## COUNCIL OFFICER'S PLANNING PROPOSAL ASSESSMENT REPORT

<b>Planning Proposal No.</b>	IWC_PP_2018_03
<b>Address</b>	36 Lonsdale Street and 64-70 Brenan Street, Lilyfield
<b>Proposal</b>	<p>Planning proposal to amend <i>Leichhardt Local Environmental Plan 2013</i> to:</p> <ul style="list-style-type: none"> <li>• Increase the floor space ratio (FSR) from 0.6:1 to 1.5:1;</li> <li>• Introduce a maximum building height development standard of RL 33.2,</li> <li>• Add a site-specific clause for objectives, minimum setbacks, maximum number of 5 storeys and non-residential development at City West Link street level.</li> </ul>

**Figure 4: Council's concept design with a 1.5:1 FSR and reduced height of no more than 5 storeys (Source: annotated over DRA drawings by Council Officers)**

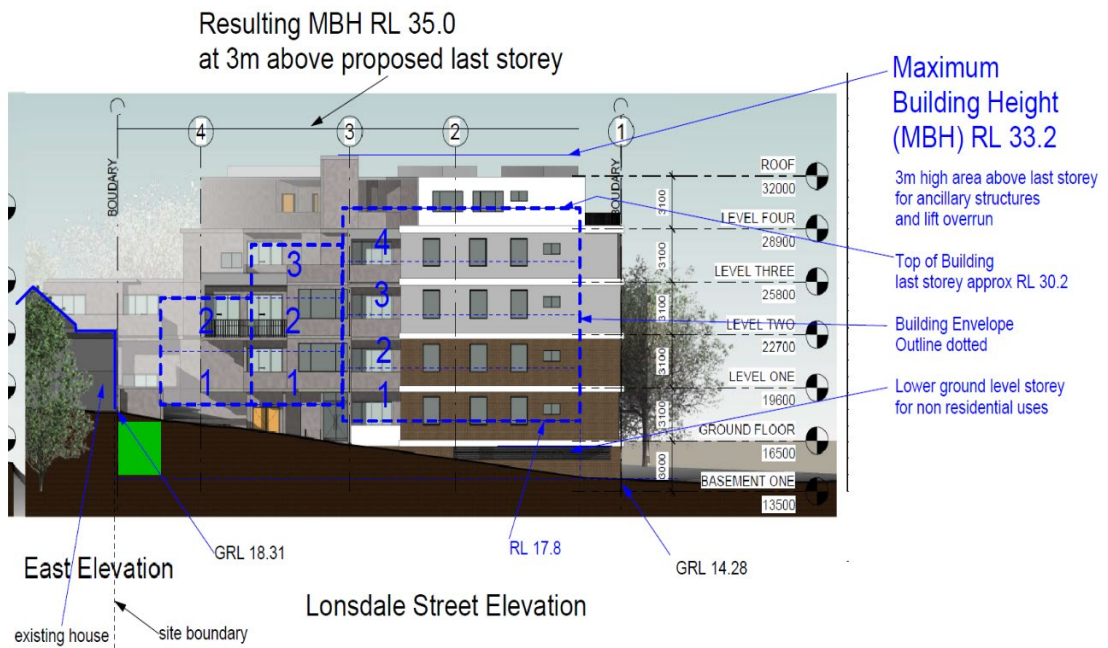
The recommended Planning Proposal would allow two (2) storey development next to the southern boundary, stepping up to a five (5) storey building on the City West Link boundary as illustrated in **Figures 4** and **5**. The 5 storey element includes a non-residential ground floor and 4 storeys of apartments.
